Reply on RC1

Author comment on "Soil moisture estimation in South Asia via assimilation of SMAP retrievals" by Jawairia A. Ahmad et al., Hydrol. Earth Syst. Sci. Discuss.,
<https://doi.org/10.5194/hess-2021-460-AC2>, 2021

Reviewer #1

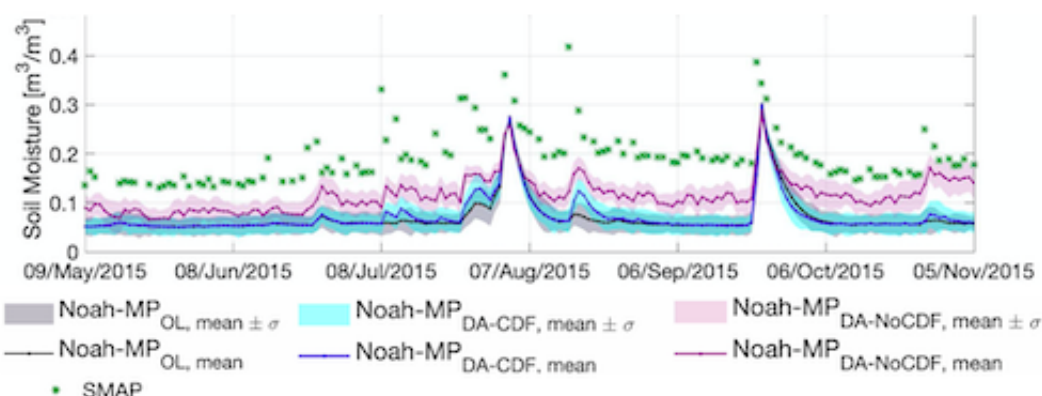
- MAJOR: The main problem with the paper is that the better results are obtained when SMAP soil moisture data are assimilated without the correction of the BIAS. Of course, the correction of the BIAS in regions in which we have irrigation, that is not modelled by the Noah-MP version used in this study, will provide wrong results. However, without the correction of the BIAS, i.e., no CDF-matching (or other methods), the assimilation method is not correct as well. Indeed, the assimilation should correct the random error, not the BIAS. The bias between modelled and satellite data is related to multiple causes, differences in spatial scale, differences in parameterization (e.g., wilting point and saturation), differences in land cover specification. A BIAS between modelled and satellite data is expected. For instance, a positive BIAS is observed also in the summer period (see Figure 4 and 7) or in areas not irrigated (Figure 4), and it cannot be easily explained. I am sure that in Pakistan and northern India the satellite soil moisture data can contribute to see the unmodelled irrigation and hence to contribute to improve land surface modelling. However, the approach used in the study should be corrected. E.g., the Noah-MP model with the irrigation module can be run. BIAS correction only during summer (i.e., in which irrigation is negligible) can be implemented (not month by month). These are just two suggestion to the authors.

As an alternative, assimilation using an anomaly-based approach (i.e., one that is zero-mean by construct) was also tested. In the interest of limiting the scope of the study, these results were not added in the paper. In this approach, the retrieval mean was mapped to the land surface model mean and updates were computed using the resultant anomalies such that:

Figure A shows a sample timeseries for a location that is 80% irrigation-equipped. It is apparent that assimilation estimates (DA-CDF) after anomaly scaling closely mimic the OL estimated soil moisture throughout the year whereas DA-NoCDF is able to update the soil moisture based on the information in the SMAP observations, particularly during the winter months. This could be further explored if in-situ measurements were available. Unfortunately, there are no publicly available soil moisture datasets across the three primary river basins in South Asia, i.e., Indus, Ganges, and Brahmaputra, from 2015 onwards.

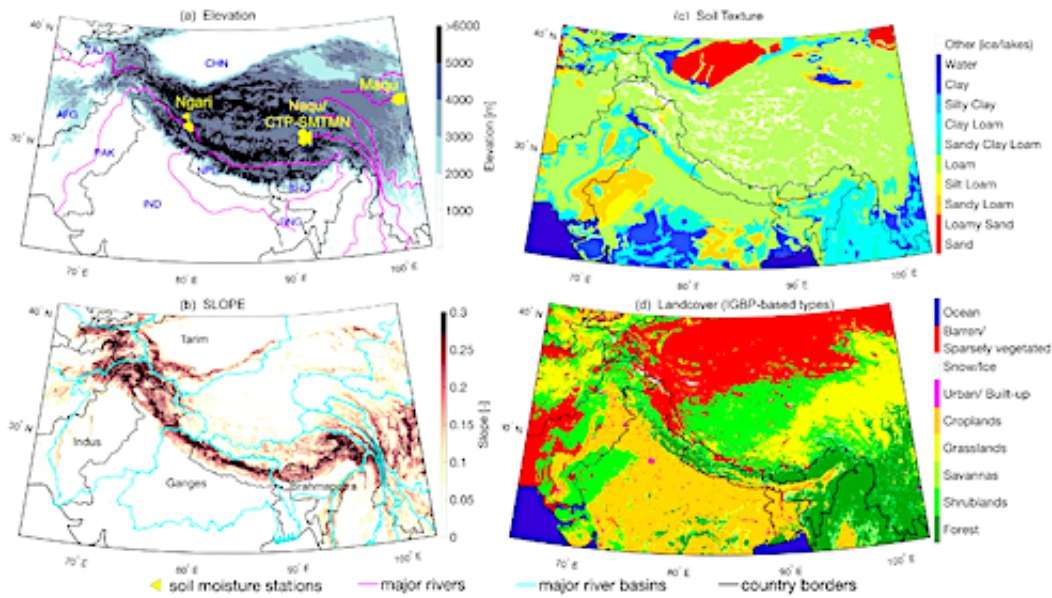
- P6, L128: Show in the map the location of in situ soil moisture stations with the name of the networks.

Response: Thank you for the comment. The network names have been added to Fig. 1.
